The Honorable Governor Kristi Noem
Governor of South Dakota
State Capitol Building
500 East Capitol Avenue
Pierre, SD 57501

The Pierre Vietnam/ERA Veterans Association (VEVA) would like to salute your efforts to improve the Capitol Grounds and, in particular, the area around Capitol Lake and the Flaming Fountain Memorial area.

Vets unhappy with memorial redesign

Monuments

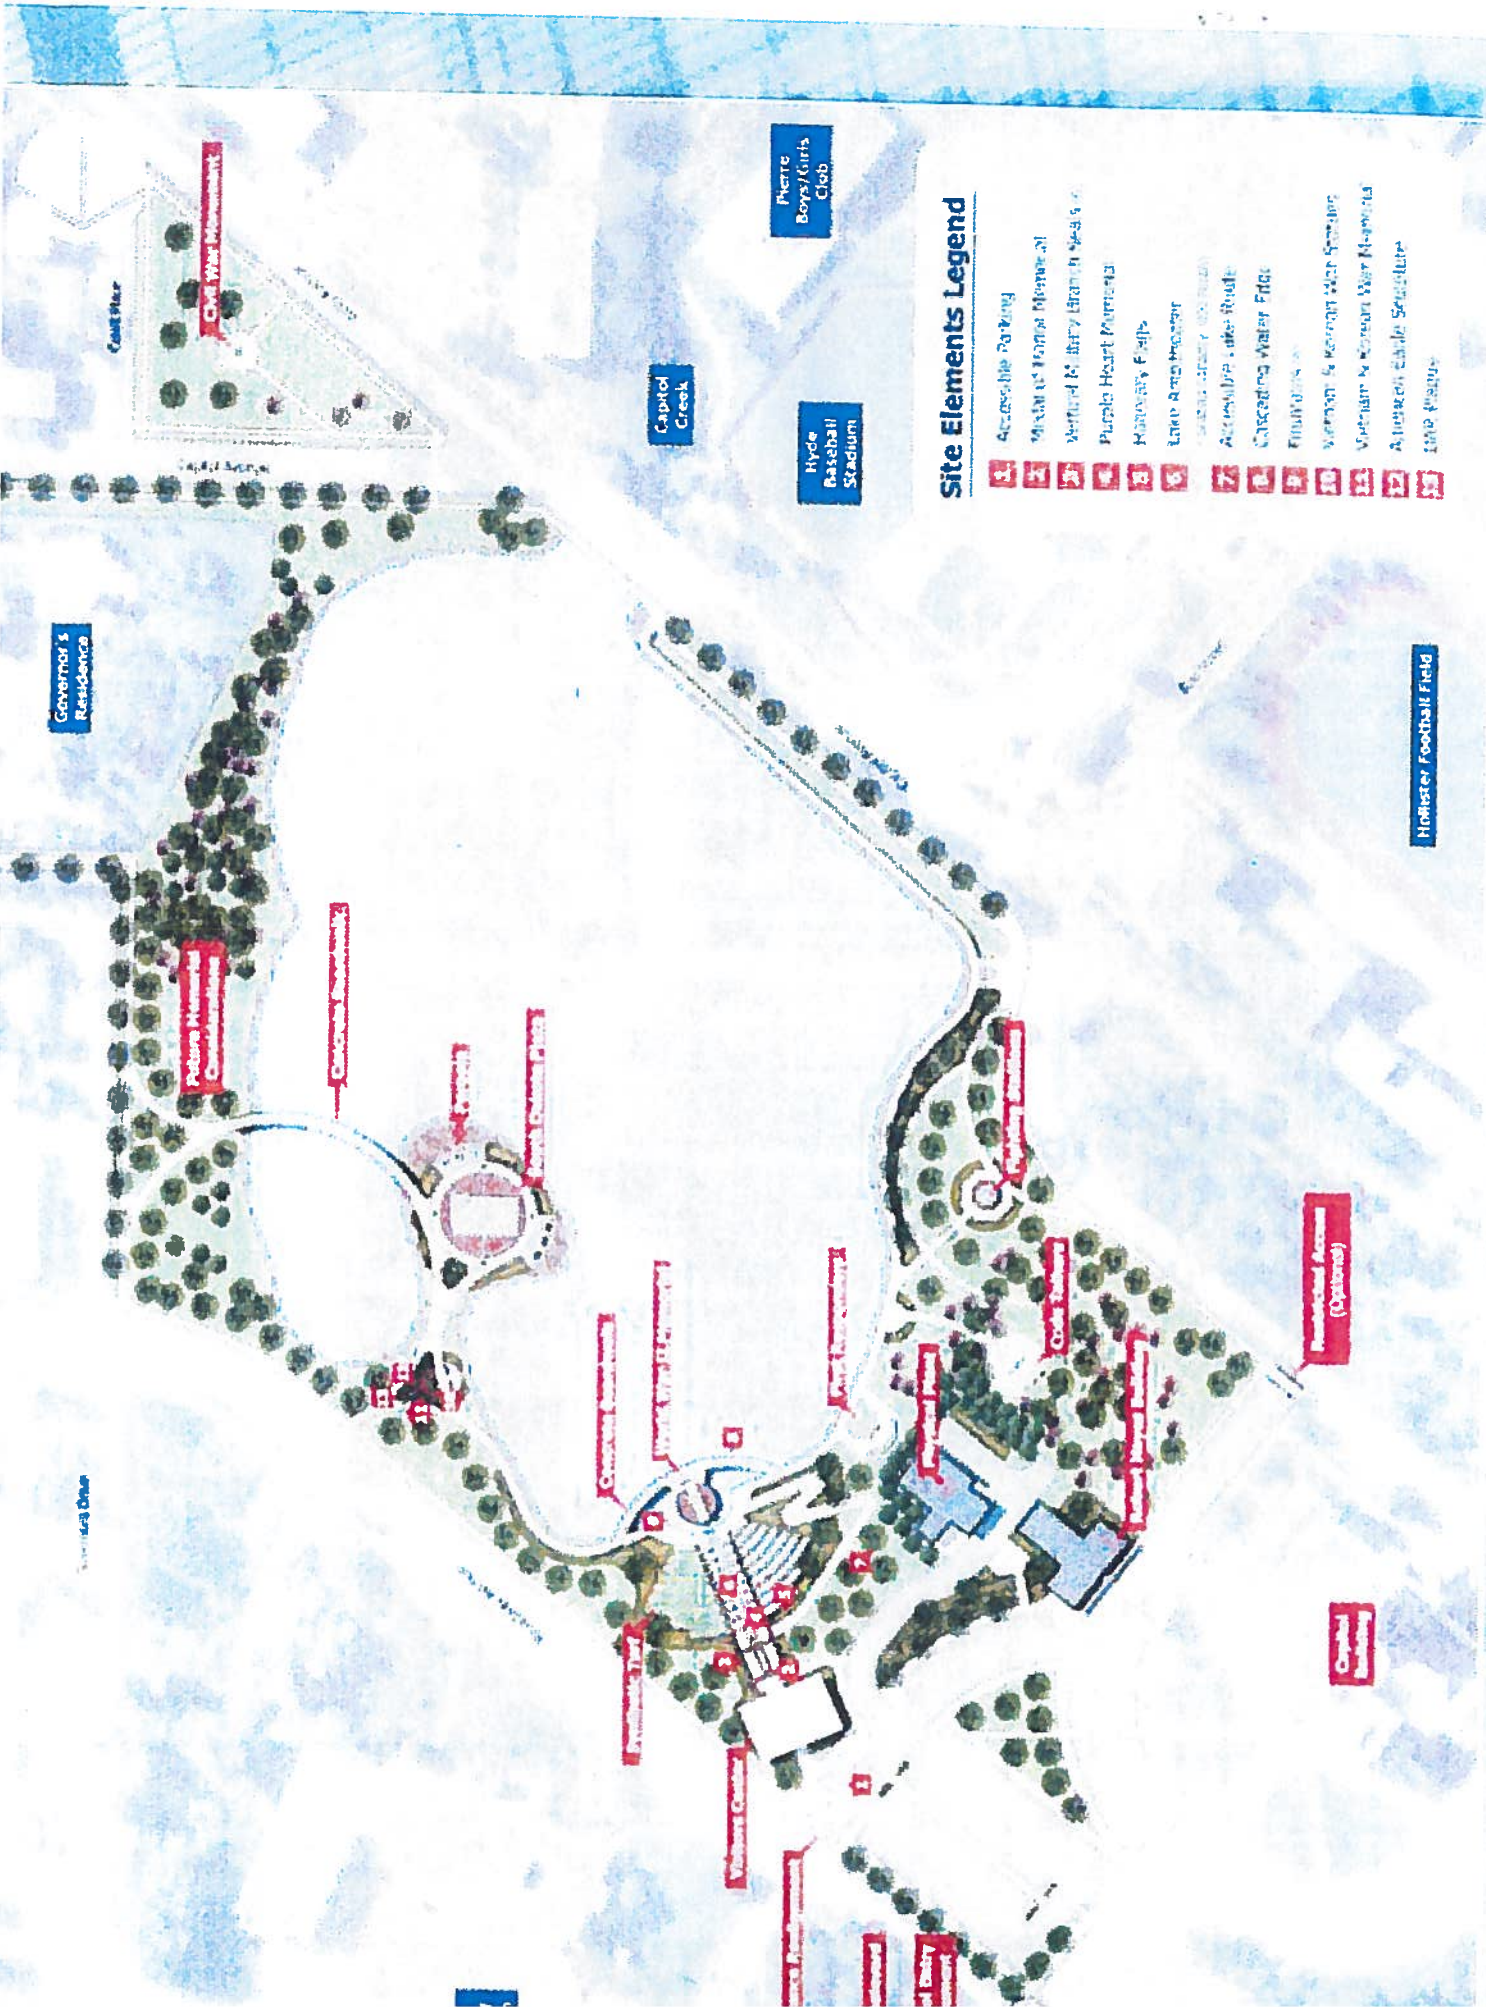
- Specific comments by VEVA members are as follows:
 1. Members were **100% in agreement** that the Korean and Vietnam Memorials **should not be relocated to the other side of Capitol Lake** and they should remain in close proximity with the other Memorials. By moving those memorials, they designers are subjugating them back to a “conflict” which they were called in the 1960’s. Anywhere that there are bullets, bombs and people dying.....it’s a WAR!

2. Members were **100% in agreement** that improvements in the Medal of Honor and Purple Heart Memorial were desirable.
3. Members were **100% in agreement** that the Code Talkers Memorial should be co-located with the other Memorials. Some members felt that moving the Code Talkers Memorial to a remote location away from the site may offend Native Americans, much akin to moving to a “special place” on the Reservation in the 1860’s. More Native American veterans need input into this subject.

4. Members were **100% in agreement** that the “Flaming Fountain” is **MANDATORY** in the Memorial Site. The existing Flaming Fountain contains the cremated remains of numerous veterans over its history. The Flaming Fountain is a sacred place and is known worldwide as the place where “South Dakota Honors Its Veterans.” The issue can easily be resolved by a dignified water fountain, supplied with natural gas, the flow, of which can be controlled by the central computer in Buildings and Grounds. It could be turned on and off automatically for special events and evenings remotely.

5. Members were **100% in agreement** that a new Visitor Center is appropriate however **the design does not fit the architectural décor of the Capitol.**

6. Members were **100% in agreement** with the Iraq and Afghanistan Memorial idea
7. Members were **100% in agreement** that the proposed amphitheater idea should be eliminated and those areas should be revised for Memorials and the new Flaming Fountain.

8. Members had **no comment** of relocation of EMT, Law Enforcement, or Firefighters memorials.
9. Members had **no comment** on the remainder of the Capitol Lake Improvements.

10. Members were **100% in agreement** that the proposed plan should be partially rejected and design committee revised **to include combat/non-combat veterans from Korea, Vietnam, Iraq, Afghanistan, and Native Americans on a new design committee concept with the Architect/Engineering firms from Sioux Falls.**
